## IN THE UNITED STATES PATENT AND TRADEMARK OFFICE

Applicant: Dardo Bonaparte Lujan  
Serial Number: 10/791,054  
Filing Date: March 2, 2004  
Title: Armored Assembly  
Examiner: Troy Chambers  
Art Unit: 3641

**RESPONSE TO OFFICE ACTION**

FIG. 16

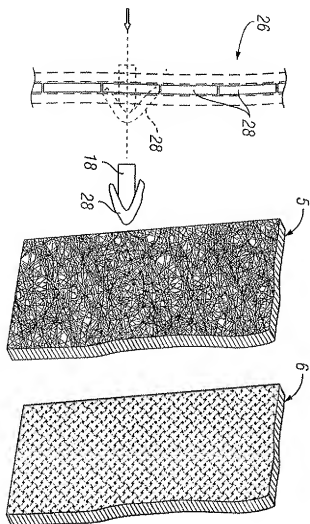
The attached sheet of drawings includes changes to Fig. 16. This sheet, which includes Fig. 15-16, replaces the original sheet including Fig. 15-16. In Fig. 16, elements 5 and 6 from Fig. 1 have been added to Fig. 16.

In the Office Action, the Examiner has again objected to the drawings under 37 CFR §1.83(a) in that the drawings are deemed not to show every feature of the invention. Specifically, the Examiner contends that the “at least one projectile stopping panel” (Claims 15, 16), “the impact cushioning panel” (Claim 28), and “the projectile stopping panel comprising loosely-entangled fibers” (Claim 29) are not shown in the drawings. In the previous Office Action, Applicant pointed out to Examiner that these features were already shown in FIGS. 1 and 9. During an informal telephone conversation with Examiner on August 8, 2006, Examiner noted that these features are not shown in FIGS. 15 and 16, which represent specie E elected with traverse by Applicant pursuant to a restriction requirement. Examiner also stated that he would not look outside FIGS. 15 and 16 for the above referenced features.

Pursuant to Examiner’s suggestion that he will not look at any other figures other than FIGS. 15 and 16 for the features of the invention, replacement drawing sheets are attached to this response clearly depicting the “at least one projectile stopping panel” (Claims 15, 16), “the impact cushioning panel” (Claim 28), and “the projectile stopping panel comprising loosely-entangled fibers (Claim 29) in FIG. 16. Specifically, the “at least one projectile stopping panel” and “the projectile stopping panel comprising loosely entangled fibers” are identified by reference numeral 5. The “impact cushioning panel” is identified by reference numeral 6.

Paragraph 0042 of the published application refers in the description of FIG. 1 to “at least one projectile-trapping panel 5.” Likewise, the specification at paragraph 0070 refers to “at least one projectile-stopping panel, or trapping panel”, which indicates that the terms “projectile trapping panel” and “projectile stopping panel” are used interchangeably. Such panel is now clearly depicted in FIG. 16 and identified by the reference numeral 5.

The “projectile stopping panel comprising loosely entangled fibers” in claim 29 is also shown in FIG. 16. Applicant respectfully refers Examiner to the preceding paragraph indicating that the terms “projectile stopping panel” and “projectile trapping panel” are used interchangeably. To the extent Examiner believes that the “loosely entangled fibers” portion of claim 29 is not shown, Applicant refers Examiner to paragraph 0055 of the specification, wherein it is disclosed that “the projectile-trapping panels 5 ... may comprise a mass of loosely-entangled microfibers 15, FIGS. 1 and 2.” The same paragraph goes on to state that “the term ‘microfiber’ must be understood as encircling all kind of fibers, filaments, threads and the like.” The term “loosely entangled” is defined in paragraph 0057 of the specification. The term “loosely entangled” is also described and claimed in U.S. Patent No. 6,684,468, col. 4, l. 45 through col. 5, l. 12 and claim 1. Therefore, “the projectile stopping panel comprising loosely entangled fibers” in claim 29 is now depicted in FIG. 16 and identified by reference numeral 5.

Applicant also respectfully submits that the “impact cushioning panel” referred to in claim 28 is now shown in FIG. 16. In paragraph 0043 the specification discloses “at least one impact cushioning panel 6, see FIG. 1”. Again, Applicant respectfully refers Examiner to the description of FIG. 16, paragraph 0069, which also refers to FIG. 1 and incorporates the ballistic panels of FIG. 1 by reference into the description of FIG. 16. Because the “impact cushioning panel”, “the projectile stopping panel”, and “the projectile stopping panel comprising loosely entangled fibers” originally shown in FIG. 1 are now shown in FIG. 16 and identified by the reference numerals 5 and 6, Applicant requests that Examiner withdraws his objection under 37 C.F.R. 1.83(a) that these features are not shown in the drawings.
